# Access Compliance Report Public Rights-of-Way (Pedestrian Signals)

Intersection ID: N/A	Main Street:	Cross Street: N/A	Location: N/A
ADA ID: 2E4F251E4C16	Signal Type: One Push Button-Non APS	Overall Compliance: No	Severity Score: BTN 1: N/A BTN 2: N/A No BTN: N/A
Codes/Mitigation Info/Possible Solution		Field Measurements/Component Compliance

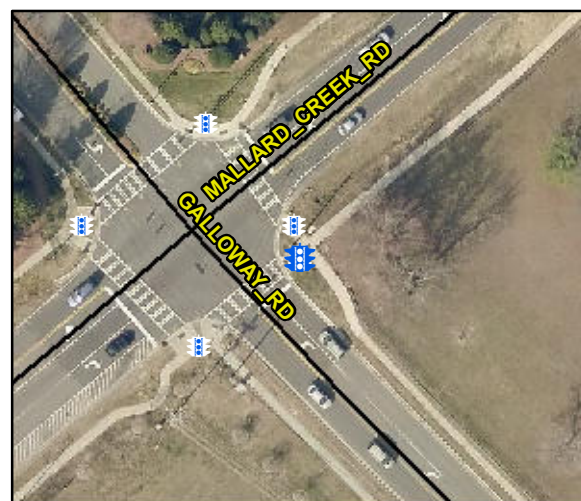
PROW/ADA: TMUTCD 4e.08, R404.2, R404.3, R404.7.3

N/A	B 1 Clear Xing Direction?	Yes	N/A	B 2 Clear Xing Direction?	N/A
	B 1 Crossing Direction	To SW		B 2 Crossing Direction	N/A
Yes	B 1 DistanceTo XWalk (in)	0.0	N/A	B 2 DistanceTo XWalk (in)	N/A
No	B 1 DistanceTo Curb (in)	17.5	N/A	B 2 DistanceTo Curb (in)	N/A
Yes	B 1 Diameter (in)	2.0	N/A	B 2 Diameter (in)	N/A

Possible Solutions: Replace Signal Push Button With APS Button on New Post. Remove & Relocate Sign.
